**RE: Point Field Landing, Lot 34R**

**Variance Application submittal**

### CONFIRMATION OF PRE-FILE

**PRE-FILE #:** 2024-0114-P  
**DATE:** 12/9/2024  
**STAFF:** Joan A. Jenkins (OPZ)  
Kelly Krinetz (OPZ)  
Habtmu Zeleke (I&P)

EXISTING CONDITIONS VARIANCE PLAN  
**POINT FIELD LANDING ~ LOT 34R**  
523 POINT FIELD DRIVE, MILLERSVILLE, MARYLAND 21108

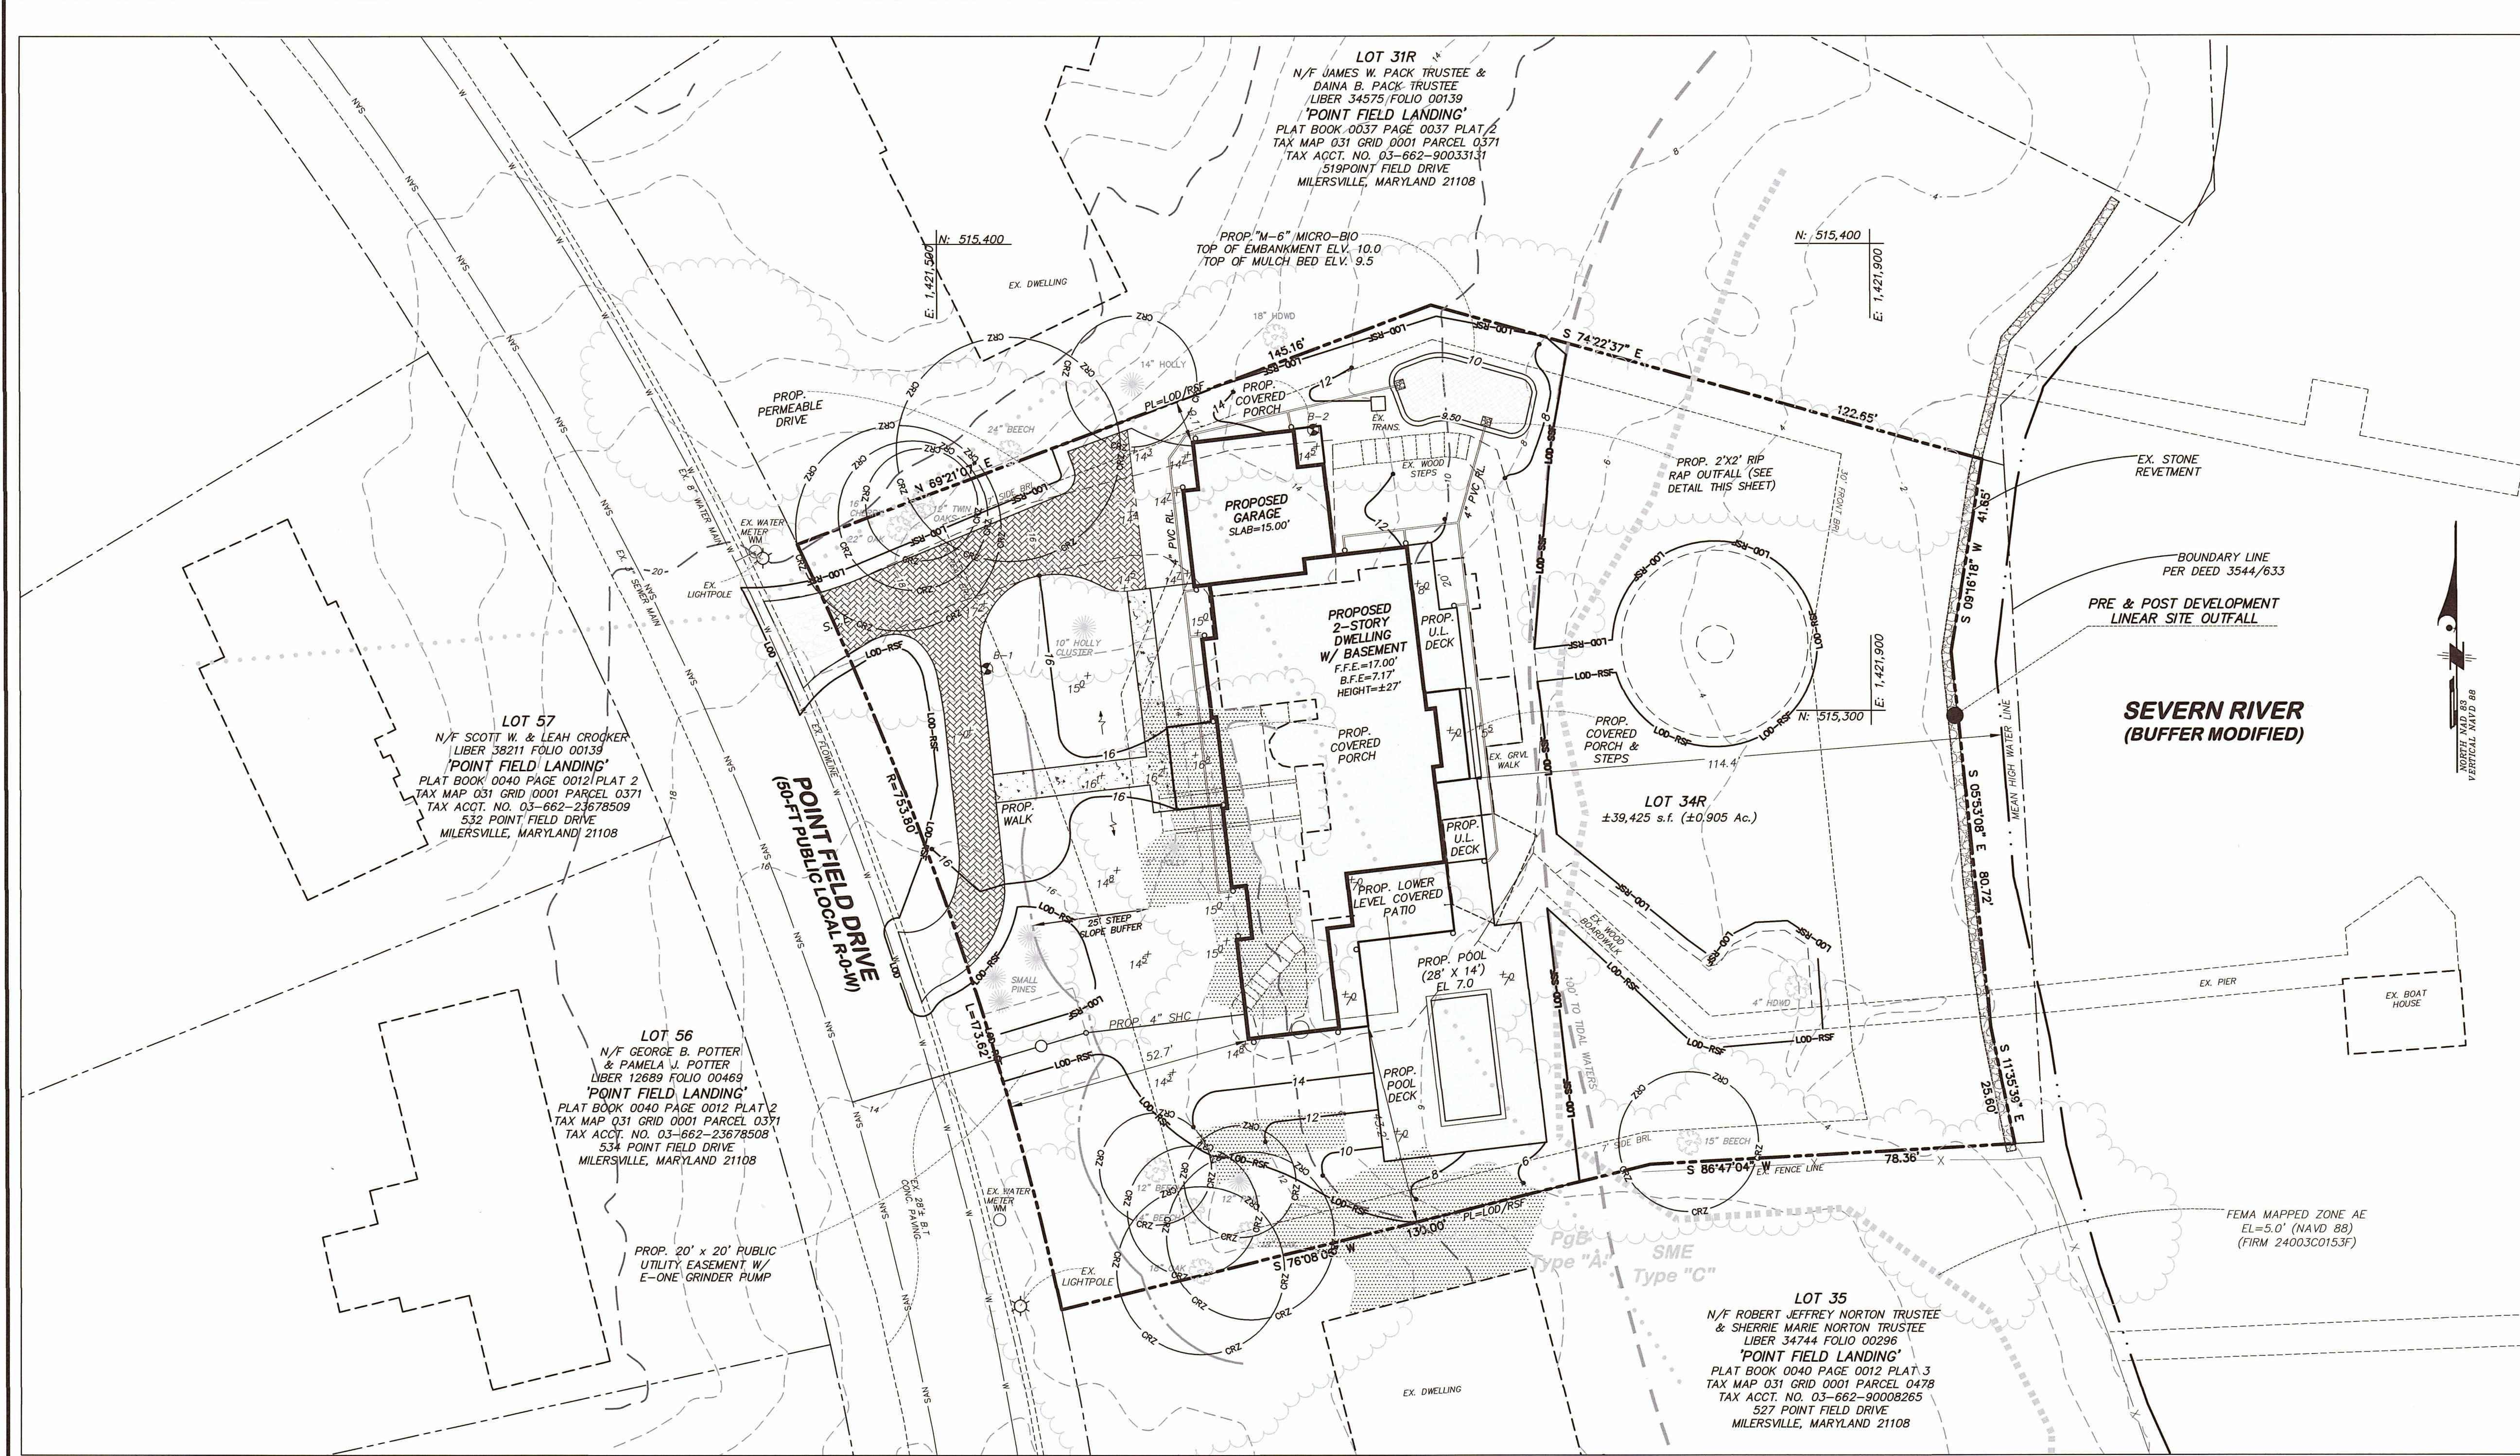
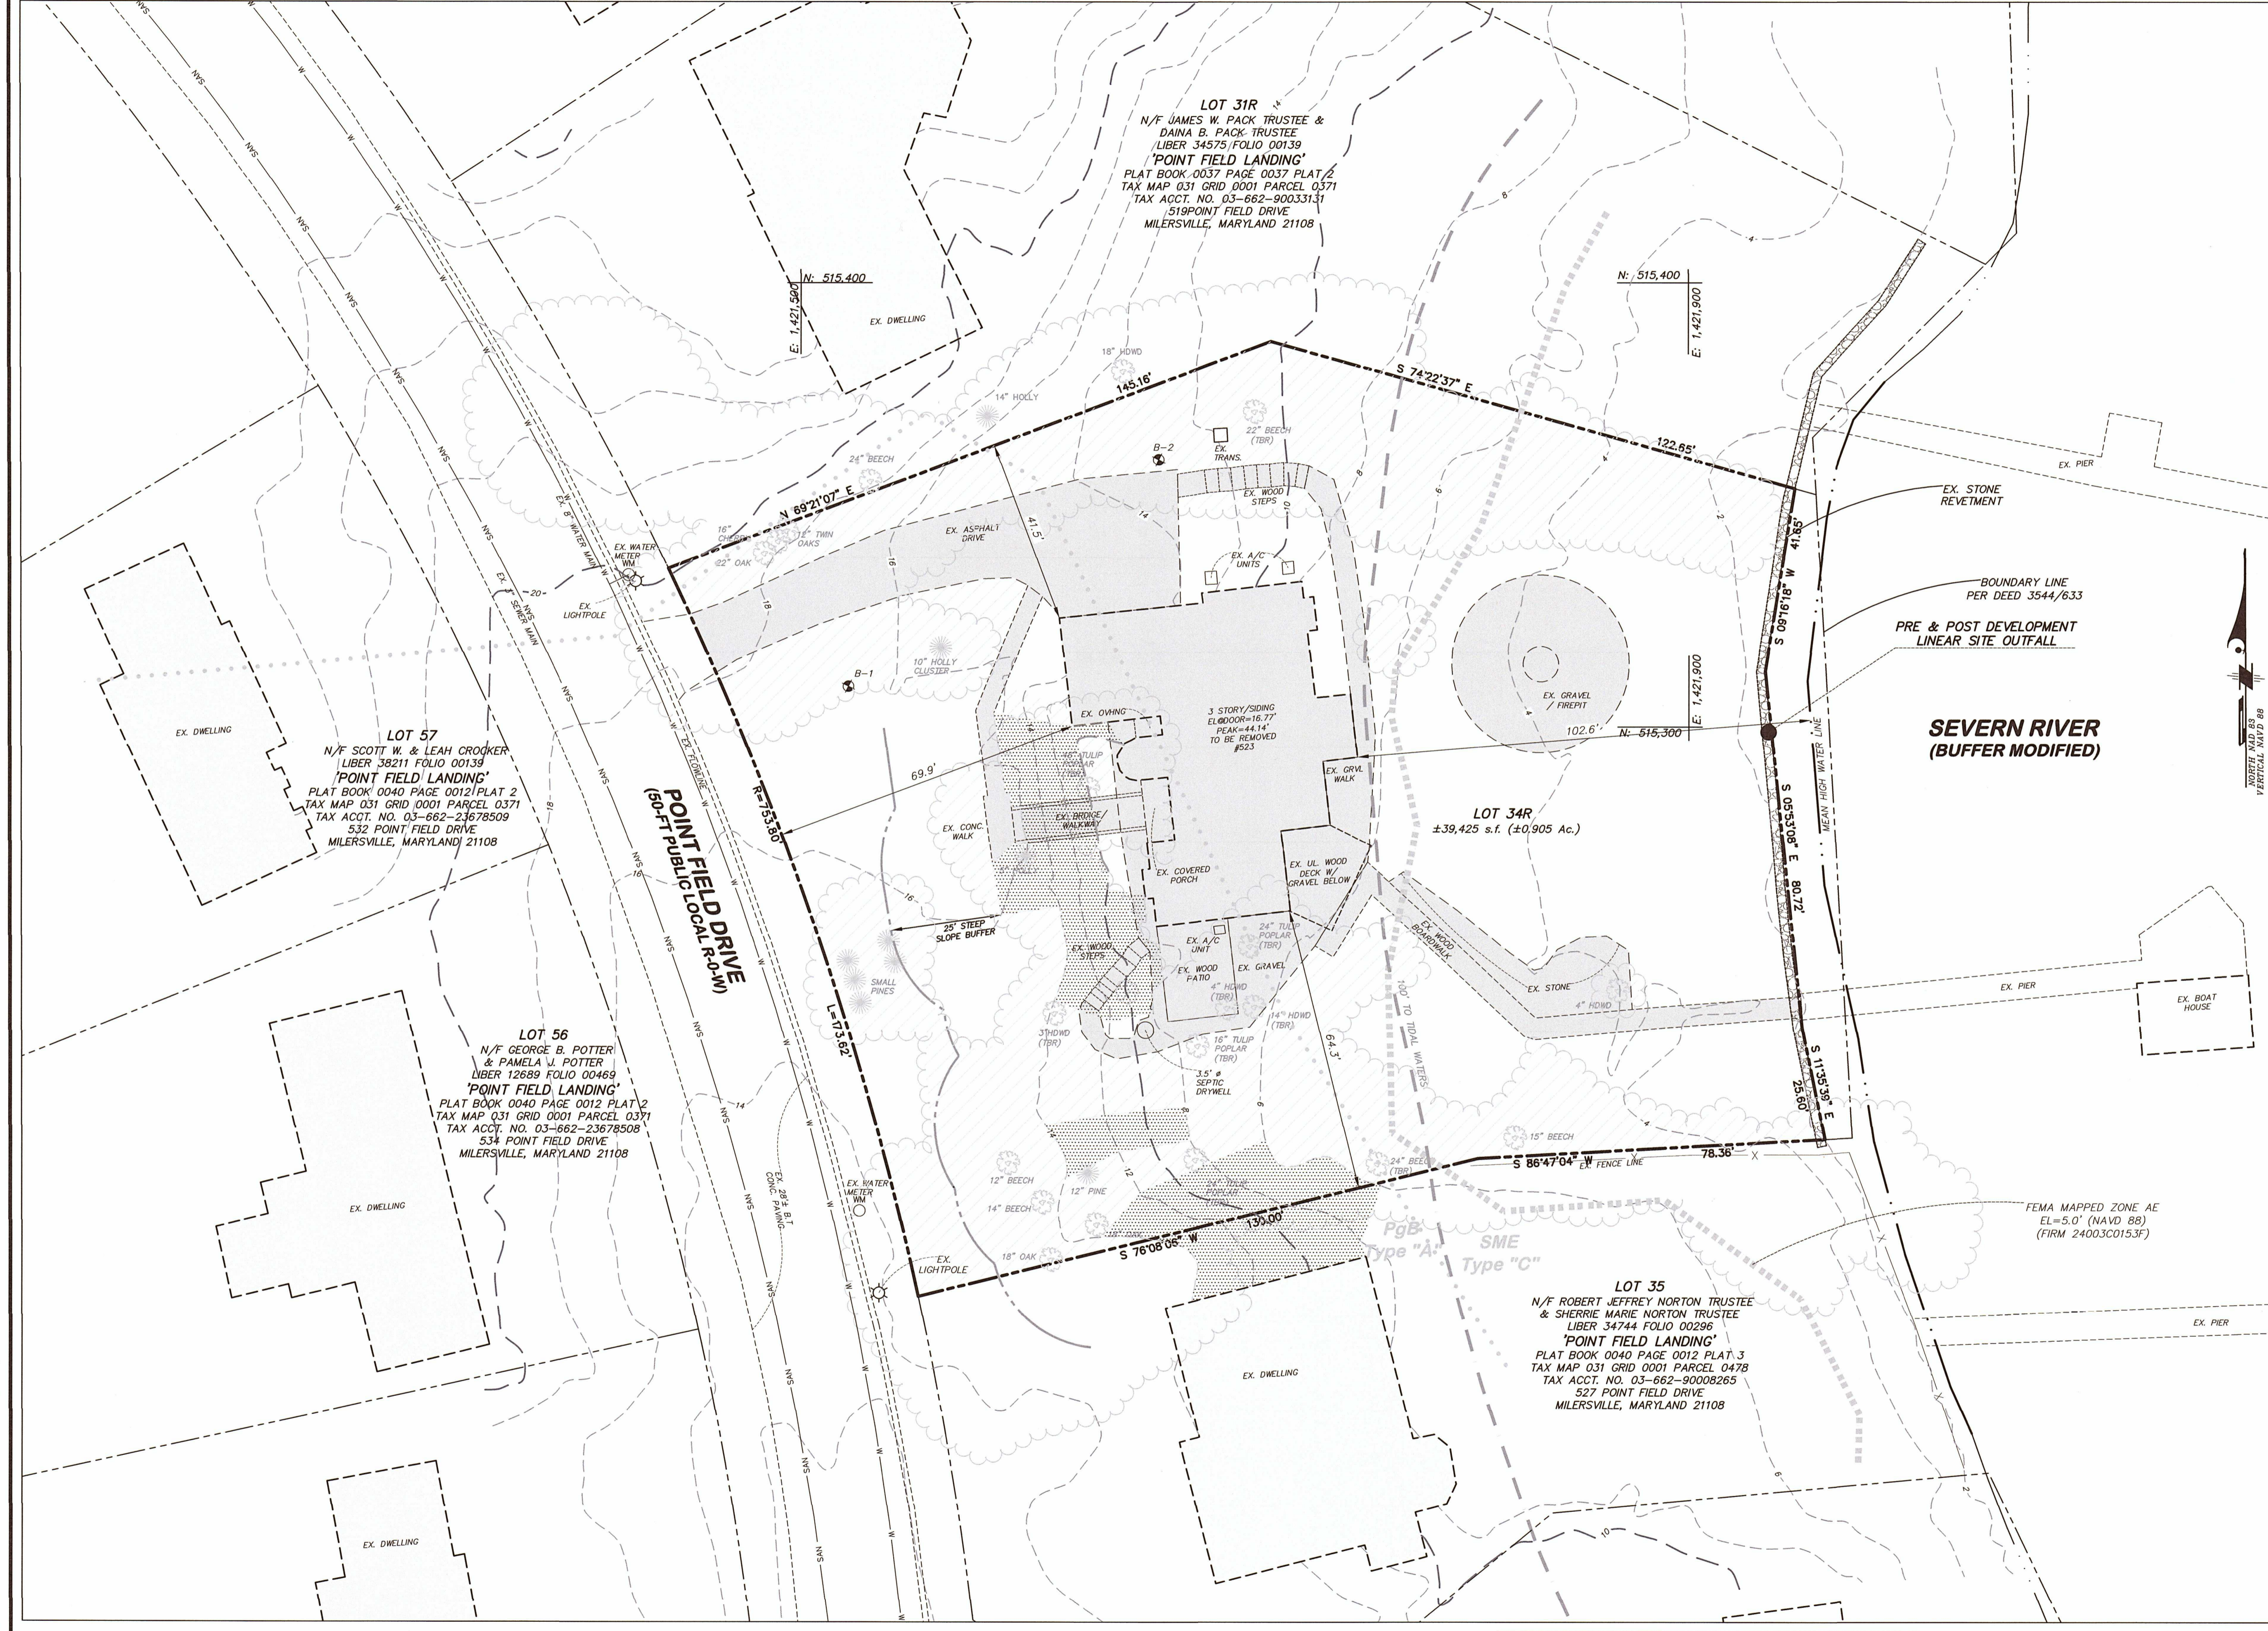
The Health Department has reviewed the above referenced request. Additional information is needed on showing the location of the existing on-site sewage disposal system and labeled to be abandoned. Also required is documentation from the Department of Public Works that the property can connect to public sewer.

DEVELOPED CONDITIONS VARIANCE SITE PLAN  
**POINT FIELD LANDING ~ LOT 34R**  
 523 POINT FIELD DRIVE, MILLERSVILLE, MARYLAND 21108  
 TAX MAP 31 GRID 1 PARCEL 371 DISTRICT 3RD  
 ANNE ARUNDEL COUNTY, MARYLAND  
 SCALE: 1" = 20' DATE: 12/30/2024 PROJ. NO: PK14324 SHEET 2 OF 3

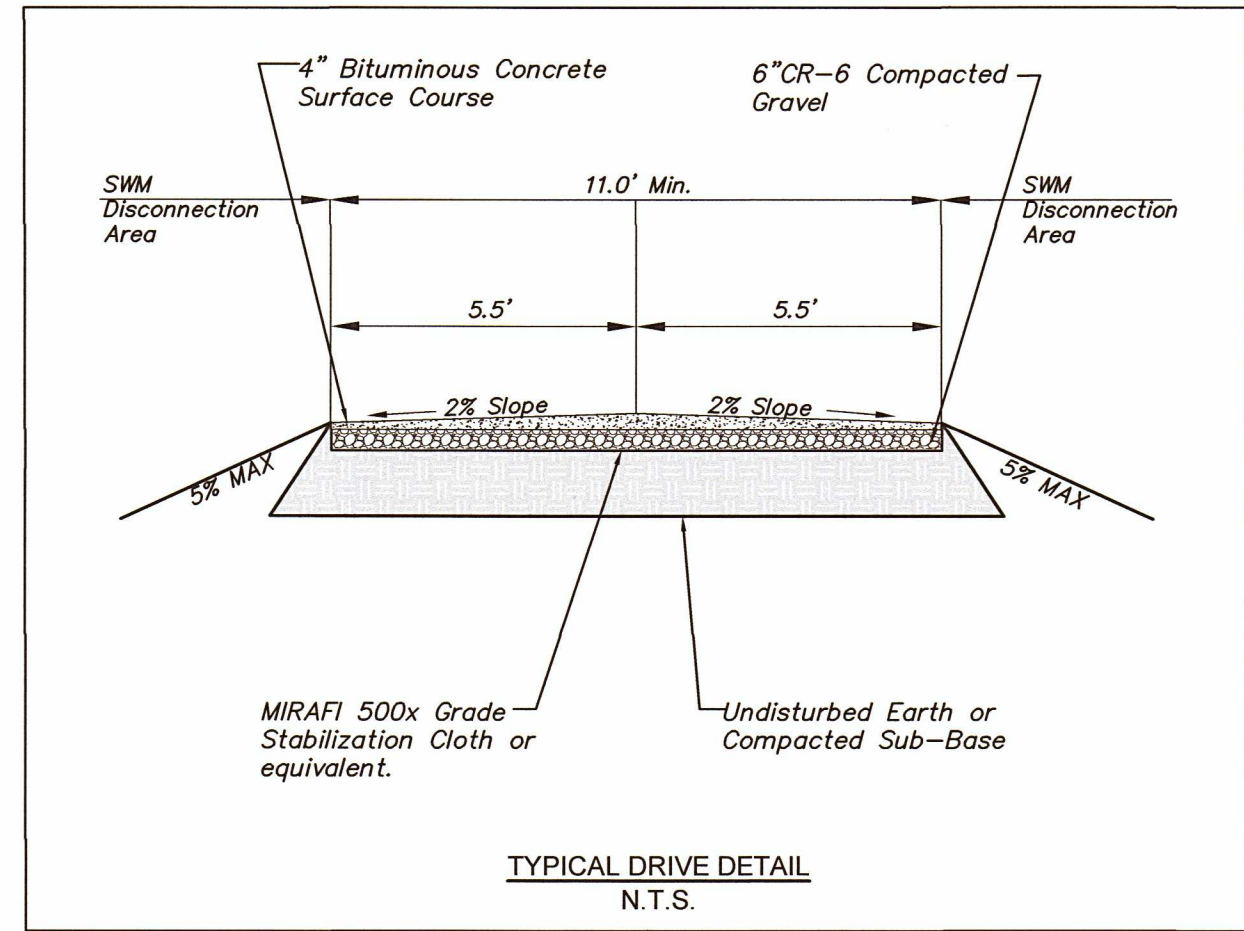
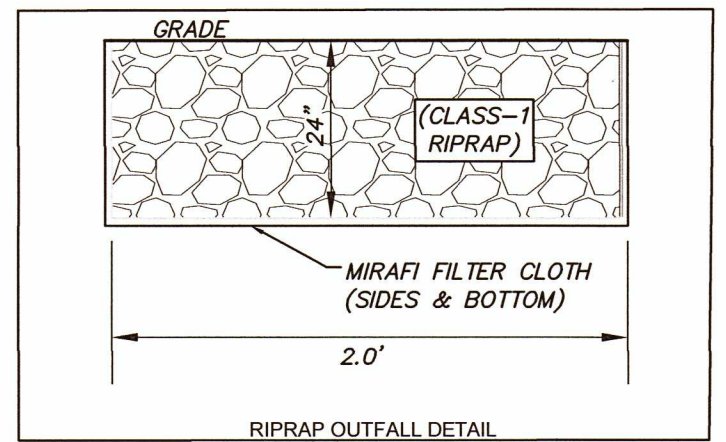
1. Stormwater management will be addressed through three micro-practices: micro-bioretenion, permeable pavement, and non-rooftop disconnections.
2. Specify the type of permeable pavement and add this to the cost estimate. Only permeable concrete or pavers are allowed. Bituminous/asphalt permeable pavement is not allowed due to the risk of accidental sealing.

3. Permeable pavements shall be located down the gradient of building structures and be setback at least 10 feet from buildings.
4. All stormwater conveyance systems shall be designed so that no building or habitable structure, either proposed or existing, is flooded or has water impounded against it during the 100-year storm event.

5. Microscale stormwater facility(ies) design should incorporate safe conveyance for overflow discharges from 2, 10, 100-yr 24-hr storm events; plans should show overland relief paths for these storm events and ensure that no structures, or properties are negatively impacted or have water impounded against during these storm events.

7. Please ensure that the minimum well and septic setbacks to proposed SWM practices are achieved.
8. Ensure the proposed improvement including runoff, seepage, and slope saturation does not adversely impact the integrity of the slope and potential impact of slope failure.

9. This reviewer is not clear on what type of SWM practice (s) proposed. Per 6.1.4 (G) of the County Stormwater Practices and Procedures manual, SWM facilities shall not be located in areas that are off-limits to development, e.g., natural resources including steep slopes and buffers.

11. A soil boring is required per practice. The suitability, and siting of proposed SWM practices should be reviewed. Soil boring information including verification of the suitability of in-situ soils for infiltration shall be submitted. Describe the site's hydrologic, and topographic characteristics and provide a recommendation on the feasibility of various BMPs.
12. Based on the plan provided, it appears that the property will be served by a public water and sewer.
13. The stormwater management, and utility/Engineering design review approval for the site shall occur at the grading permit stage.
14. The above is provided as a courtesy review as information for review and consideration comments at the pre-file.
